GOVERNMENT OF THE DISTRICT OF COLUMBIA
DEPARTMENT OF TRANSPORTATION

MEMORANDUM

SUBJECT: BZA Case No. 19020 – 1011 K Street NW

Figure 1. Proposed Site Plan (Source: Applicant)

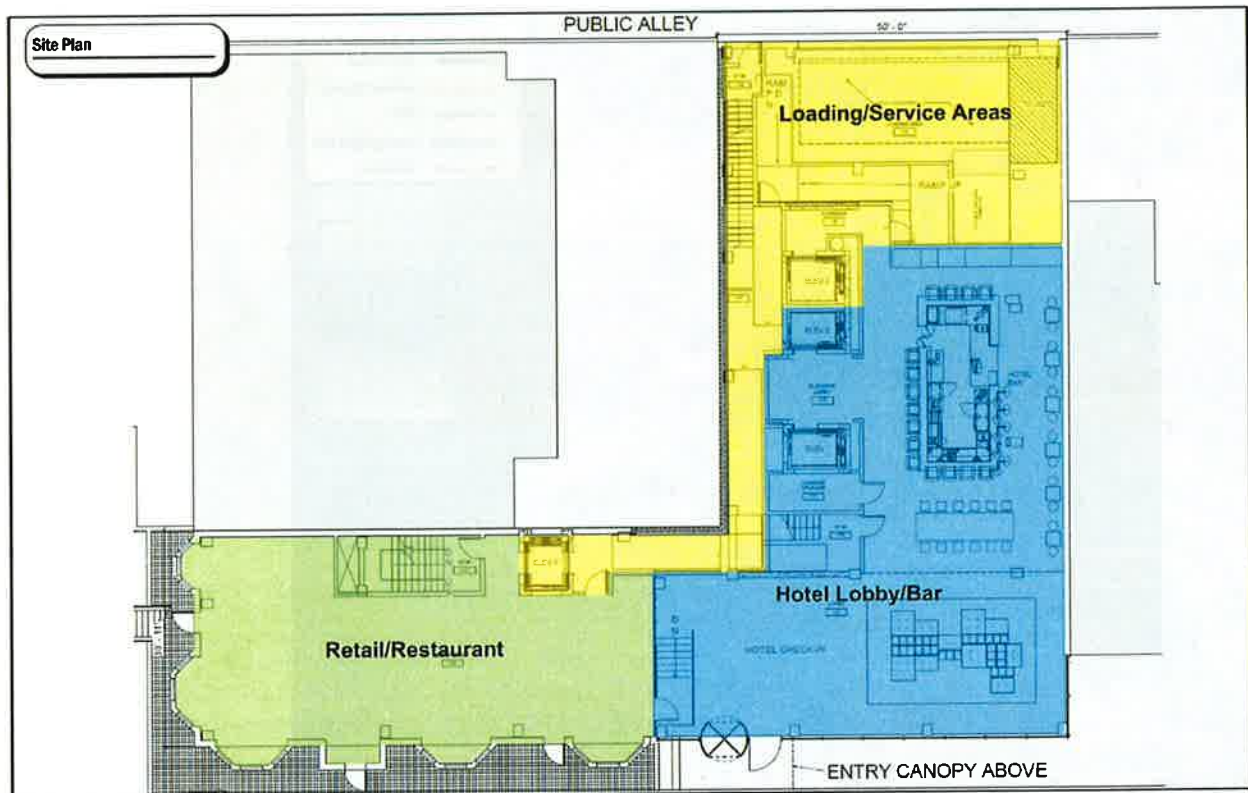
Zoning regulations require a 30' loading berth, a 20' service space, and a 100 sf loading platform. The project seeks a variance from the 20' service space requirement. The Applicant has shown the alley area will accommodate a 30' box truck, with a turning maneuver exhibit provided in the CTR, which is the most common service/delivery/moving truck anticipated. If any loading requiring larger trucks occurs, this will require a permit for on-street loading. They anticipate approximately eight deliveries daily. If these deliveries overlap, double parking in the alley, or loading from the street could become necessary, which DDOT would not want to see. As such, the Applicant is expected to address the scheduling for this loading facility. DDOT expects the Applicant to comply with DDOT's standards for loading, the detailed design of which will be further addressed as part of the permitting process for this property. With that, DDOT does not object to the sought loading variance.

- Additional loading coordination, as part of the public space permitting process. DDOT expects all loading facilities to meet DDOT standards, which includes no back-in movements across public space;
- Public space, including curb and gutter, street trees and landscaping, street lights, sidewalks, alleys, and other features within the public rights of way, are expected to be designed and built or maintained to DDOT standards. Careful attention should be paid to pedestrian and bicycle accommodations within and along the Site's perimeter and adjacent infrastructure;
- All utility vaults are expected to be accommodated on private property; and
- Greater specificity is expected as to the design of the long-term bicycle parking.

Figure 2. Parking Study Area and Parking Restrictions (Source: Applicant)

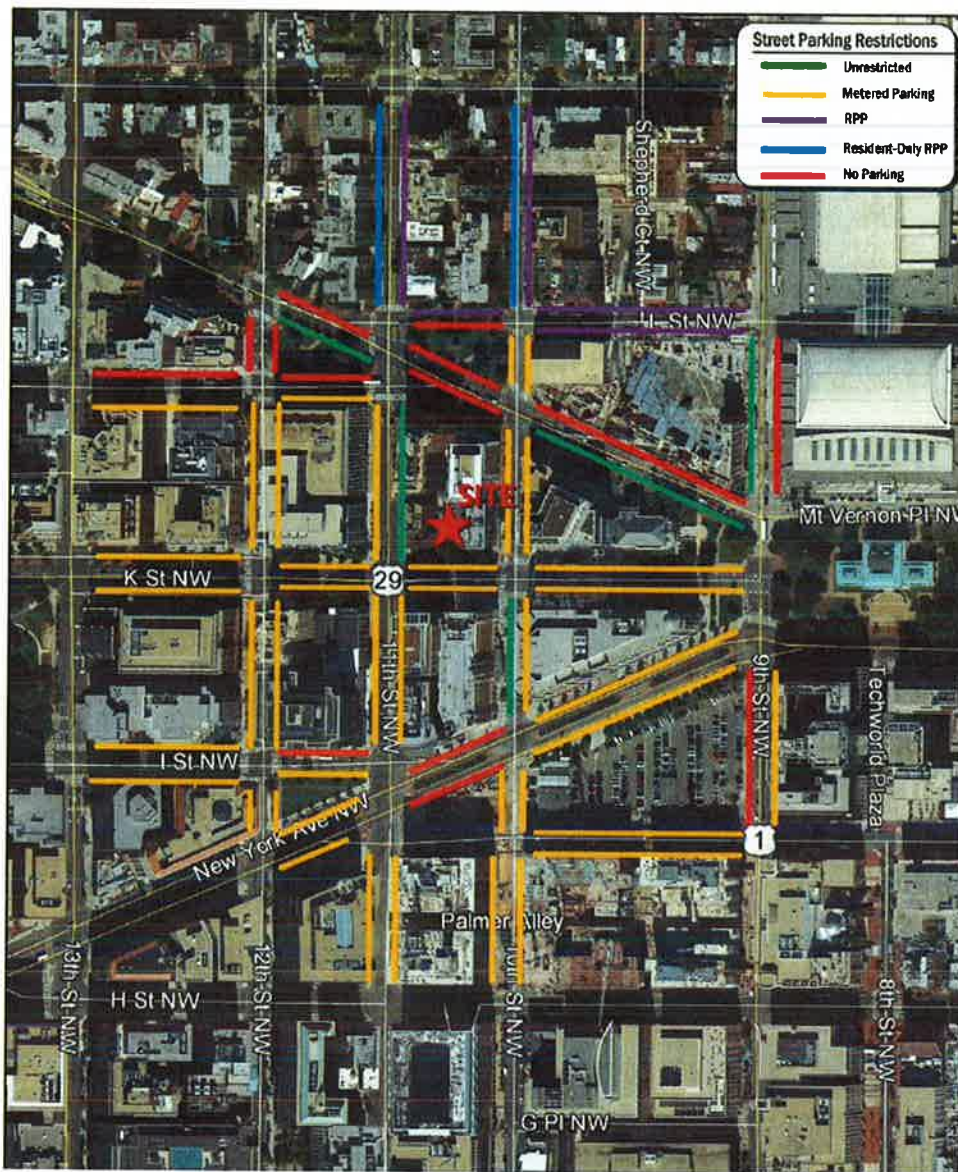
The projected trip generation for the Site expects 28 auto-based trips originating in the AM peak hour and 38 in the PM peak hour, which the Applicant states is conservative based on similar hotel usage and DDOT agrees. Existing parking utilization information for an appropriate parking study area (shown in Figure 2) was provided, and this analysis shows 130 available spaces within the study area. Furthermore, the Applicant also notes several nearby parking garages where parking might be available surrounding the site.

Generally, DDOT has no objection to reduced parking provision if documentation as to where parking could occur is made and if the overall available transportation network supports an appropriate split between vehicular, transit, pedestrian, and bicycle trips. Short-term restaurant goers, employees, and longer-term hotel dwellers could all be accommodated. Thus, DDOT finds appropriate the lack of parking provision in this area due to the close proximity to transit, provided bicycle storage, nearby available parking, and the overall relatively minor increase in vehicular trips.
